Access Compliance Report

Public Rights-of-Way

| Intersection ID: 7025 | Main Street: HUTCHISON-MCDONALD_RD | Cross Street: STATESVILLE_RD | Location: S |
| ADA ID: 18A326BA17B9 | Curb Cut Type: MedianRefuge2 | Initial Pass/Fail: Pass | Overall Compliance: No |

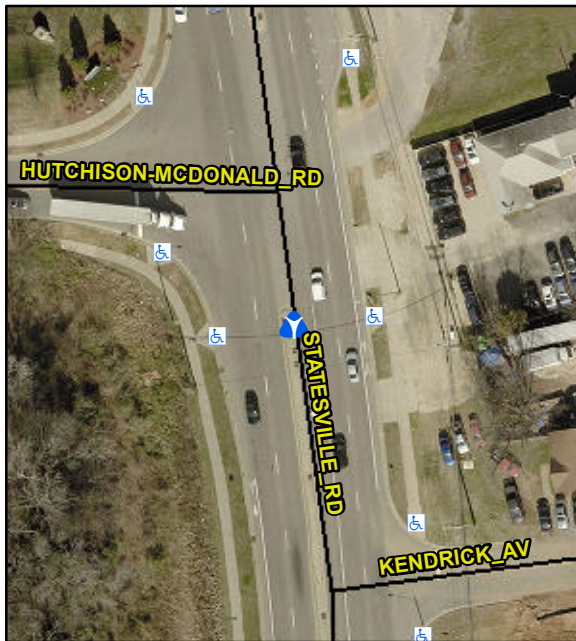
| Compliance | Description | Data | Compliance | Description | Data |
|------------|----------------------|------|------------|-----------------------------|------|
| No | Refuge 1 Length (In) | 35.0 | No | Gutter 1 Ponding? | Yes |
| Yes | Refuge 1 Width (In) | 95.0 | No | Gutter 1 Lip Ht (In) | 1.0 |
| No | Refuge 2 Length (In) | 35.0 | No | Gutter 2 Ponding? | Yes |

**Remove & Replace Entire Refuge.
Fix Gutter Ponding. Grind Gutter
Lip.**
